As agreed upon in our telephone conversation of December 31, 1963, I am sending this letter, which contains a list of questions pertaining to the interfacing of the plotter with the computer. We need the information requested herein urgently in order to proceed with the design of the plotter input/output circuits. We appreciate your assistance in helping us to obtain this information.

In accordance with the [redacted] specification entitled, "Engineering Specification for [redacted] 490 Computer Input/Output System, PX2099," and dated May 8, 1962, we will be using one computer output cable. Specifically, the operation of the coordinatograph will require the use of 30 data lines, the OUTPUT ACKNOWLEDGE line and the OUTPUT DATA REQUEST line. We will not require the EXTERNAL FUNCTION line.

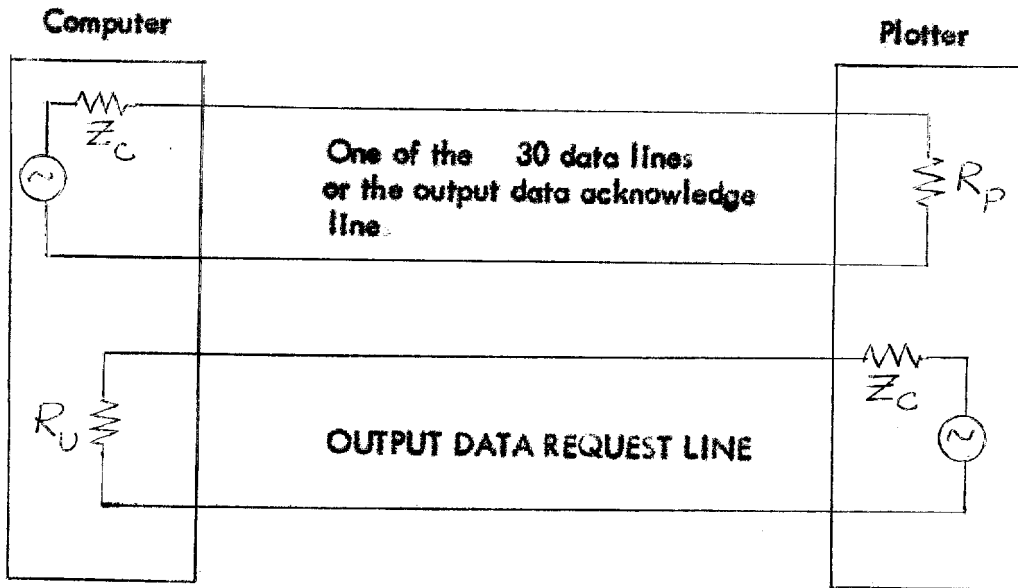
In the attempt to comply with the two requirements stated in the above paragraphs, which on the surface would seem to be contradictory, we suggest the following interconnection scheme:

It is our plan to design the input impedance of each of our 31 input data circuits (which will terminate the 30 data lines and the OUTPUT DATA ACKNOWLEDGE line), to be greater than 1,000 ohms so as to limit the current drawn from each of these 31 lines to less than 3 milliamperes. (Specifically, we intend to set R_p at approximately 3,000 ohms.)

Since the characteristic impedance of a line is undoubtedly lower than R_p , there will be a reflection at the plotter end of the cable. However, if the output impedance of the computer output amplifier is matched to the line, as we are assuming that it will be, the reflection at the plotter end of the line will be of no consequence. Please indicate if this scheme is acceptable and/or if our understanding is correct,

Similarly, we would design the output impedance of our output amplifier which will excite the OUTPUT DATA REQUEST line to match the characteristic impedance of the line so that reflections from the computer terminal would be of no consequence.

In addition, we would design this amplifier so that the line-to-line impedance, i.e. the impedance from one wire to the other in a single twisted pair, would be greater than 100,000 ohms when the plotter is turned off, in accordance with paragraph 6.2.6. of the specification referred to above. Is this foregoing interpretation of paragraph 6.2.6. correct?

- 7.A. What is the input impedance of the [redacted] input amplifier? (i.e. the OUTPUT DATA REQUEST line input amplifier) STATOTHR
- 7.B. Are we correct in setting the line-to-line impedance at greater than 100,000 ohms with power turned off or should we set the impedance from either line to ground at greater than 100,000 as indicated in paragraph 6.2.6., and if so, to which ground?
8. As you indicated in a previous telephone conversation, the schematics of input and output amplifiers which are used to interface the computer and peripheral equipment to the cable are available from [redacted] and that it is possible to purchase these amplifiers. Would you please send to us copies of these schematics along with the price and delivery information on the amplifiers.
